FY 2012/2013 Design Standards

Overview

- New Design Standards Process
- Changes to the Design Standards
 - Roadway, Landscape, ITS and Planning Standards
- Design Standards Revisions
 - What are Design Standards Revisions?
 - When do you expect them?
 - How do you incorporate them?
- New Website Design
 - How to use it
 - What is there and what isn't

Index 400 Sheet 13

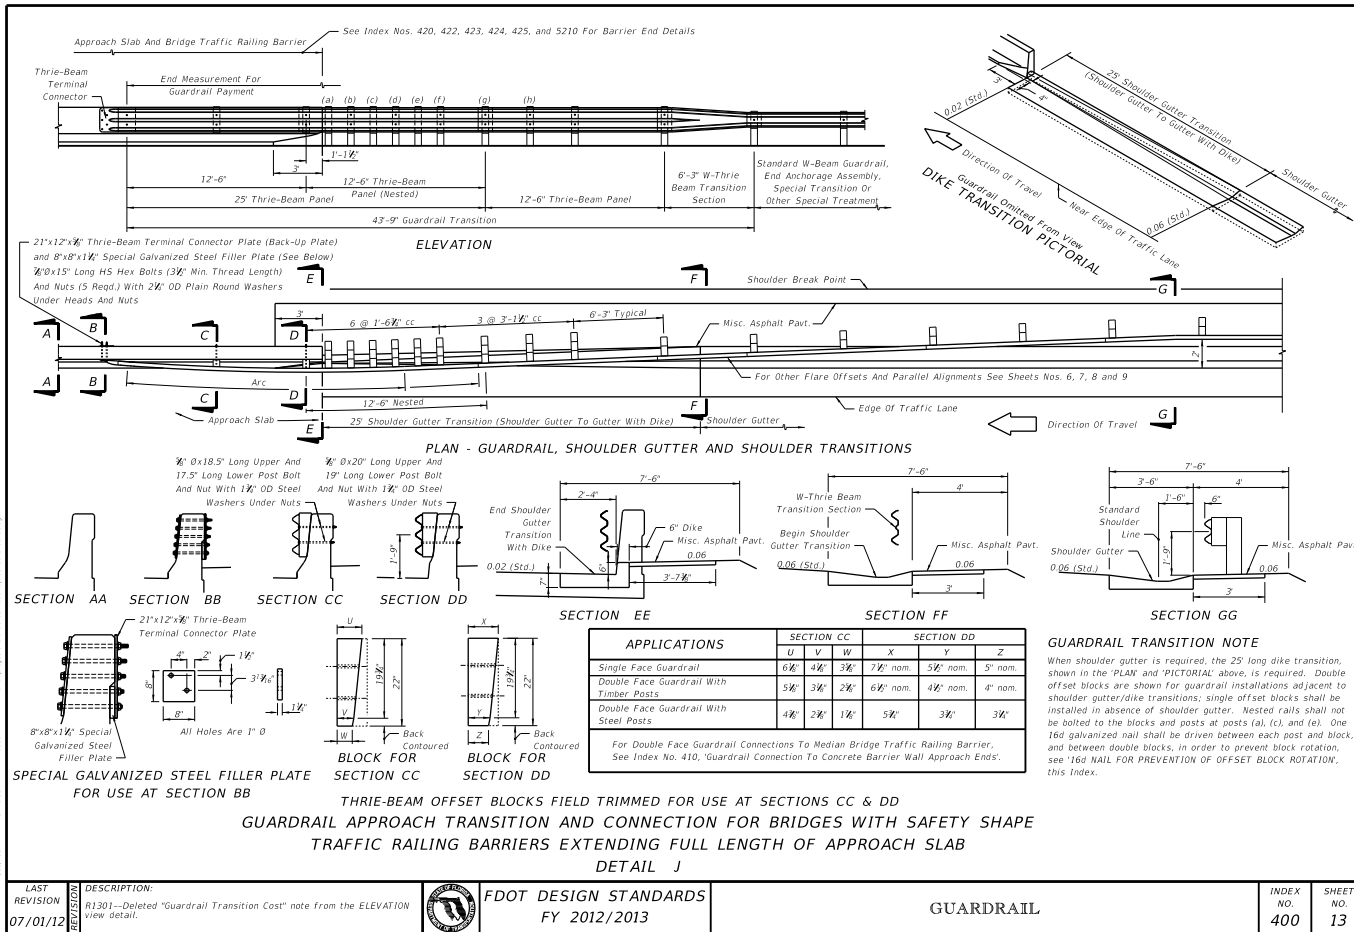
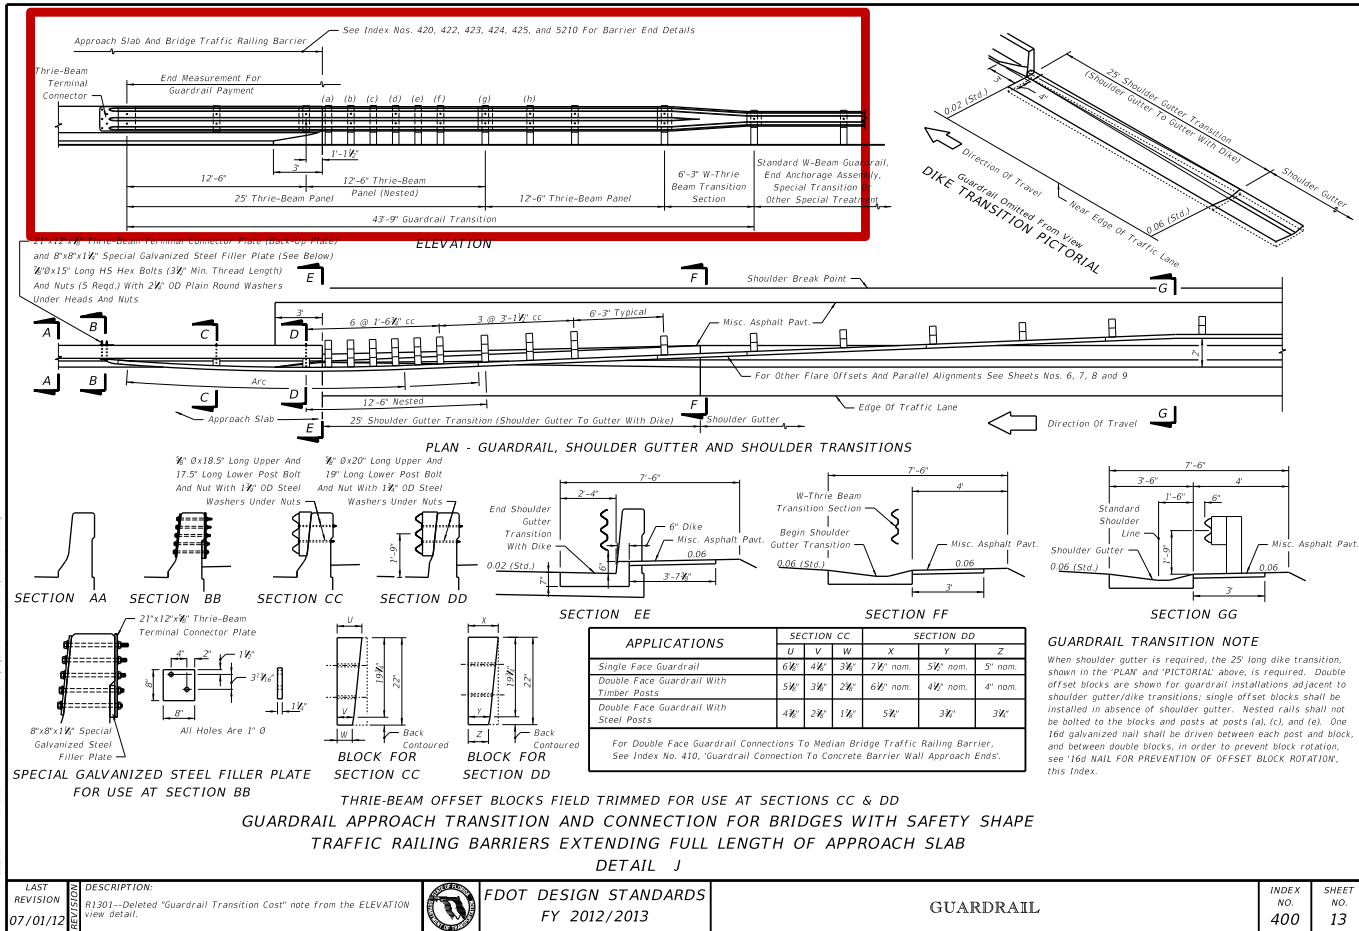
DESCRIPTION: R1301-Deleted "Guardrail Transition Cost" note from the ELEVATION view detail.

Index 400 Sheet 18

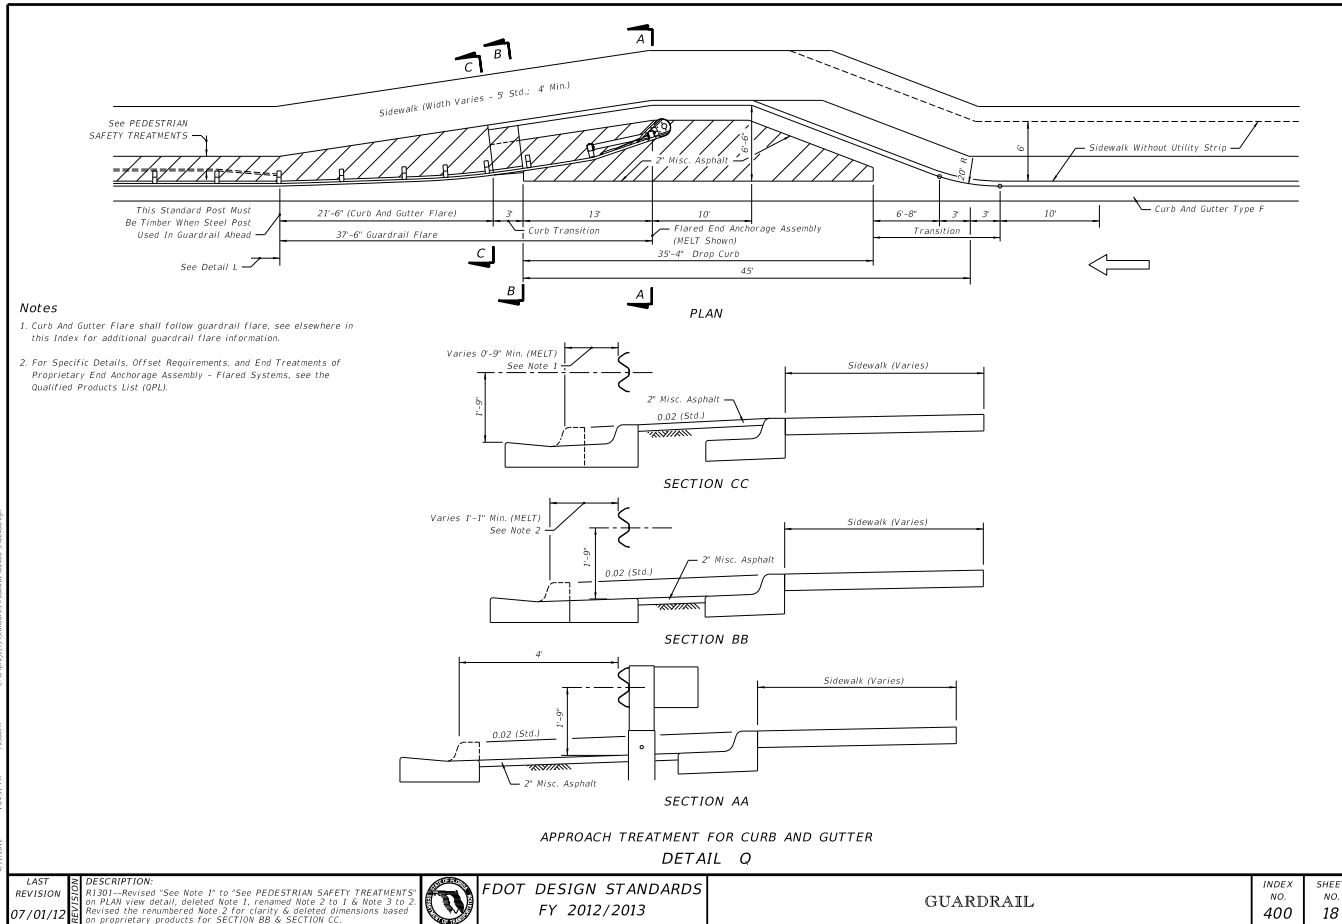
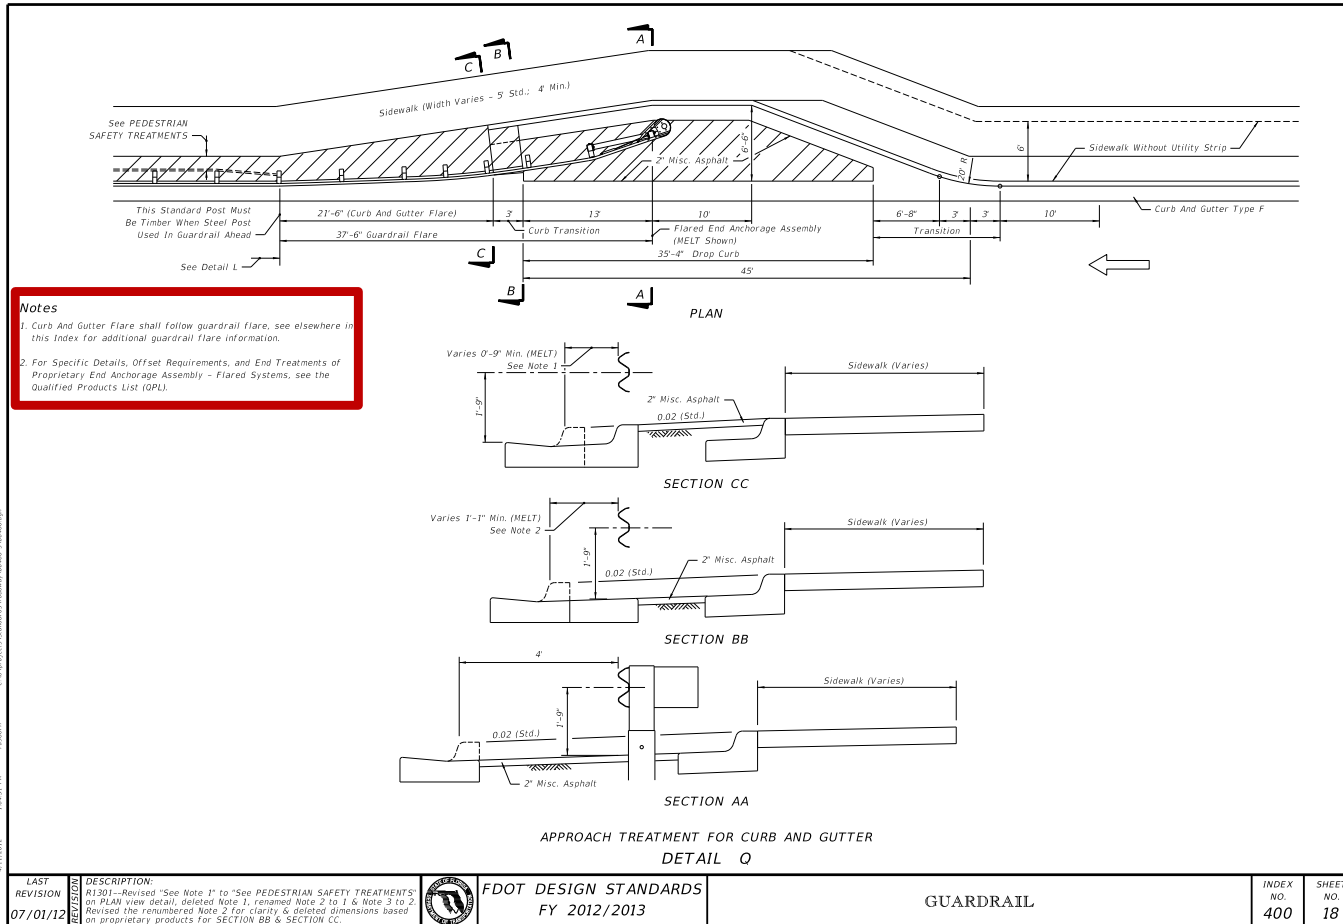
- Revised "See Note 1" to "See PEDESTRIAN SAFETY TREATMENTS" on PLAN view detail,
- Deleted Note 1, renamed Note 2 to Note 1 and renamed Note 3 to Note 2,
- Revised the renumbered Note 2 for clarity,
- Deleted dimensions based on proprietary products for SECTION BB and SECTION CC;

(Sheet 22)

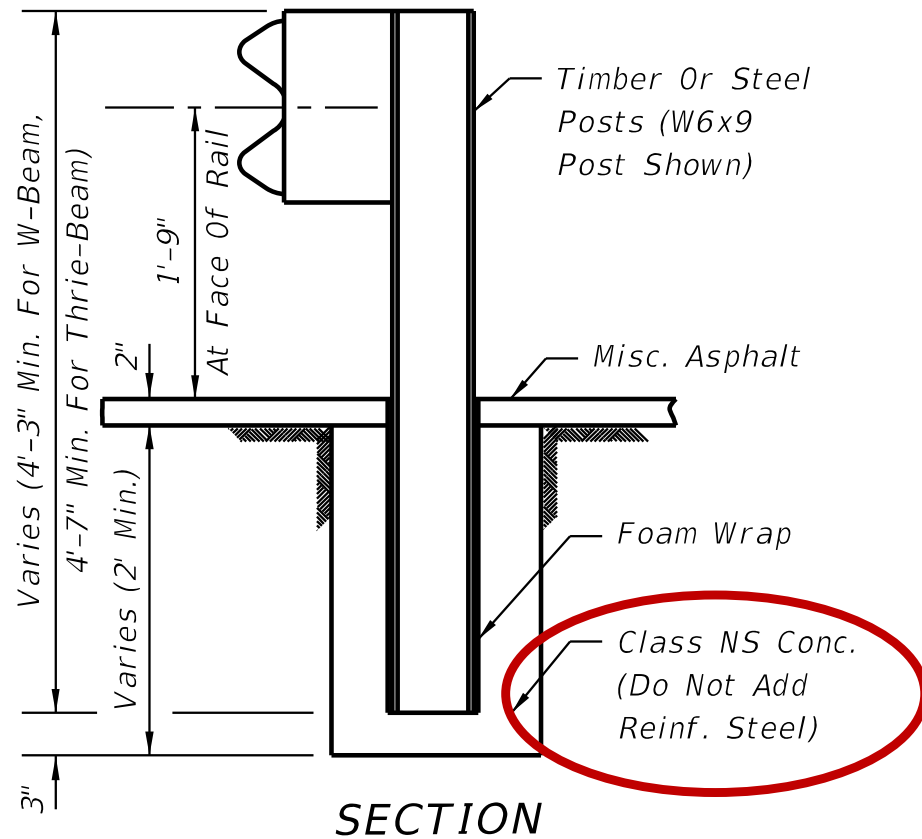
- Revised the "Class I " concrete label to read "Class NS" concrete on SECTION detail
